Amendments to the Drawings:

Please amend Figure 4A by amending the text in block 204 as follows.

FIG. 4A

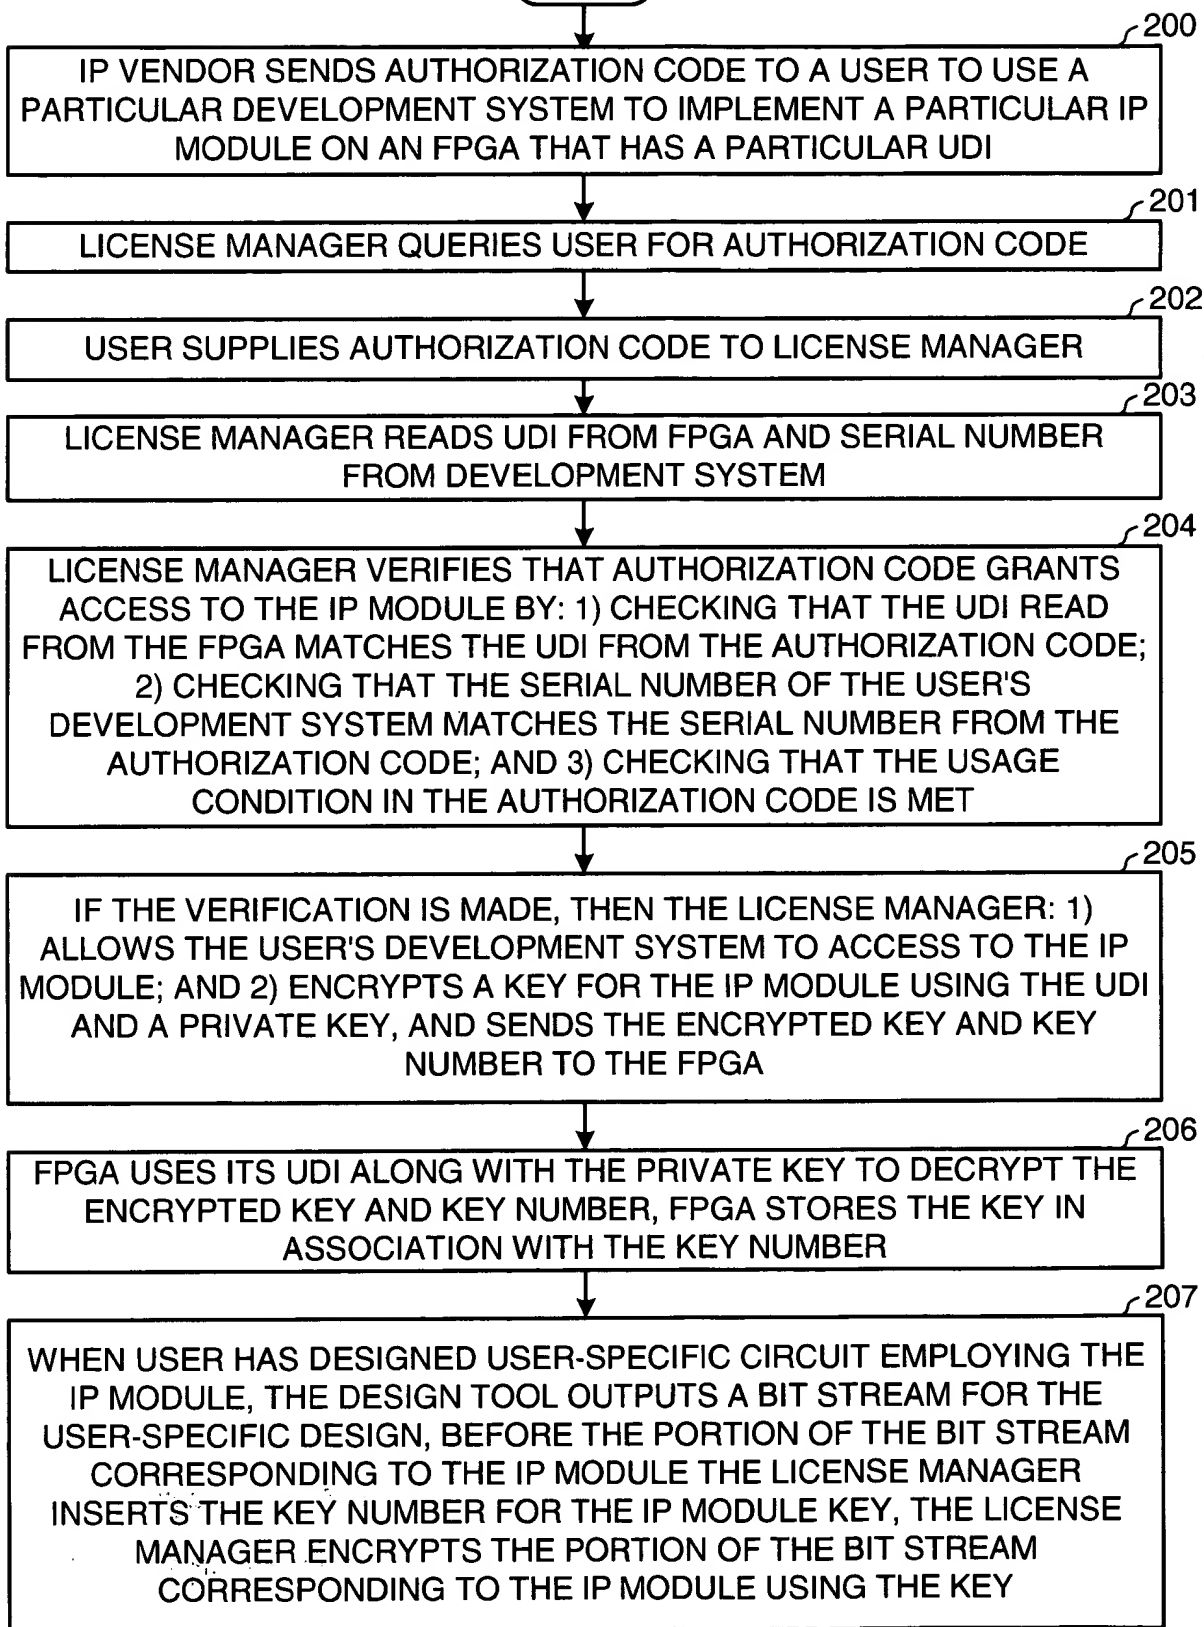
LICENSE MANAGER VERIFIES THAT AUTHORIZATION CODE GRANTS ACCESS TO THE IP MODULE BY: 1) CHECKING THAT THE UDI READ FROM THE FPGA MATCHES THE UDI FROM THE AUTHORIZATION CODE; 2) CHECKING THAT THE SERIAL NUMBER OF THE USER'S DEVELOPMENT SYSTEM MATCHES THE SERIAL NUMBER FROM THE AUTHORIZATION CODE; AND 3) CHECKING THAT THE USAGE CONDITION IN THE **[[UDI]]** AUTHORIZATION CODE IS MET
